SERVICE BULLETIN

Subject: Bell 407 Suspension Beam Interference

Helicopters Affected: Bell 407

Parts Affected: Kits installed under P/Ns & STC listed in Table 1

Figure 1 – Unintended travel stop at fastener heads (circles) versus intended travel stop (arrow) of Suspension Beam.

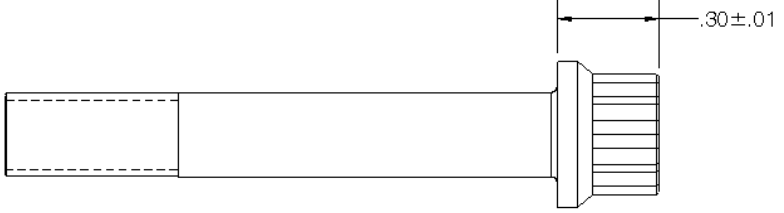
Description: Onboard Systems has been notified of interference between the Bell 407 Suspension Beam and Pillow Block mounting fasteners. This interference can act as an unintended travel limiter in the aft direction and cause fretting wear on the Suspension Beam.

- 1) **Check Beam for sign of interference.** Inspect the Bell 407 Suspension Beam by pivoting it towards the aft direction, as far as possible. Ensure that the Suspension Beam makes full travel to the stop present at the Pillow Block. Verify that the Pillow Block mounting fastener head is not an unintended travel stop. Ensure sign of contact (paint chipping, fretting) is not present.

Figure 4 – Pillow Block mounting fasteners, exploded view

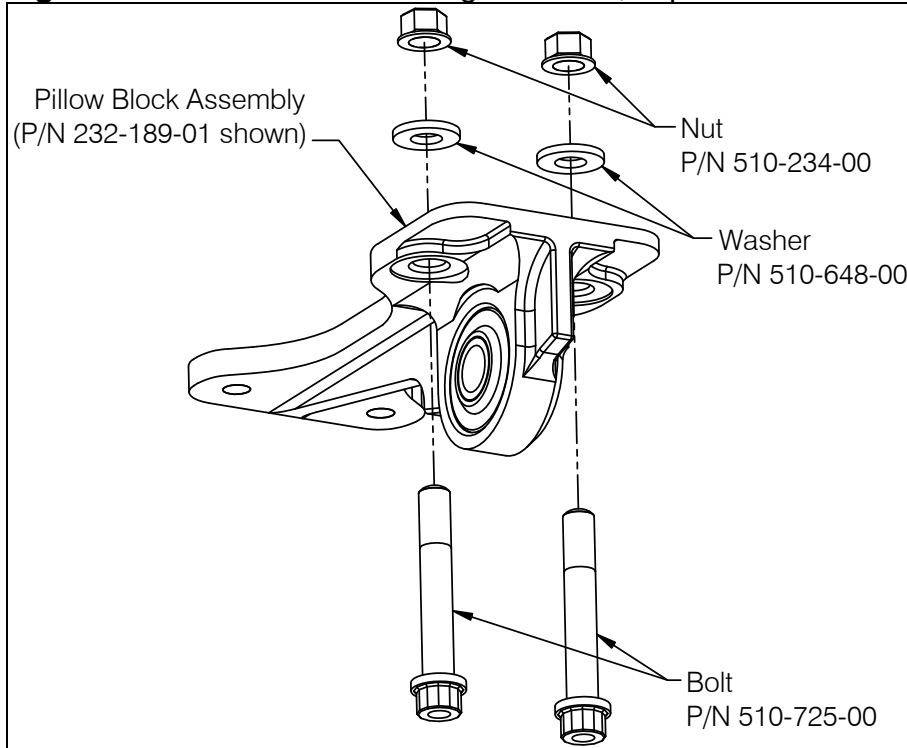
2. One at a time, remove and replace offending fasteners, P/N 510-725-00. Note: the Pillow Blocks *do not* need to be fully removed from the aircraft (they are typically sealed in place). Replace self-locking nuts (P/N 510-234-00) with new and torque nuts to 84 – 107 in-lb [9.1 – 12.1 Nm], plus drag torque. See figure 4 below:

Figure 5 – Suspension Beam rework areas

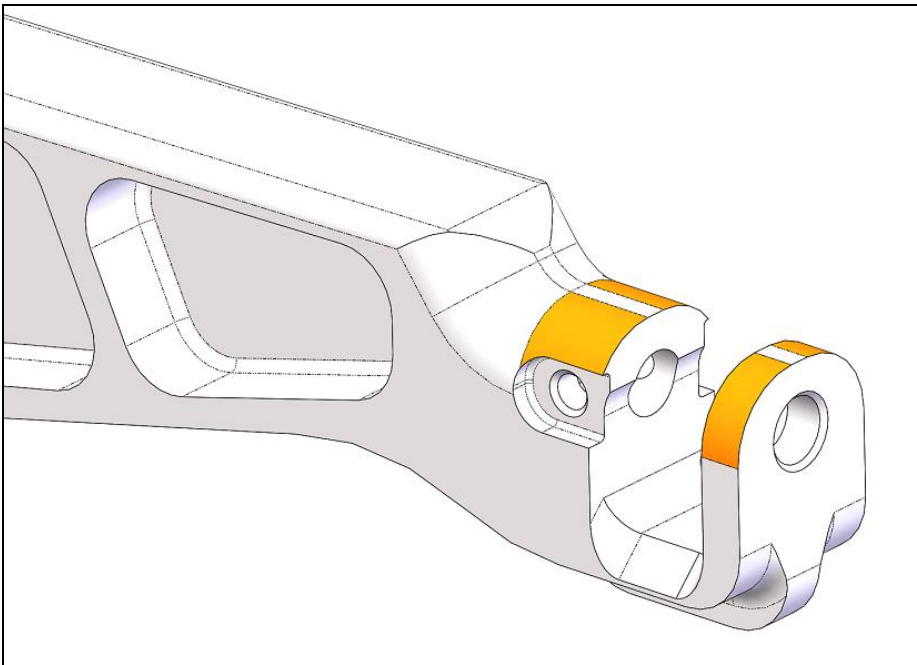
5. Accomplishment of this section requires returning the Beam (P/N 290-852-01) to Onboard Systems for rework. As CNC machining is involved, the rework modification is not readily accomplished in the field. Onboard Systems will re-machine, inspect & re-finish the Suspension Beam lug areas to drawing conformance in the filleted areas shown in Figure 5.
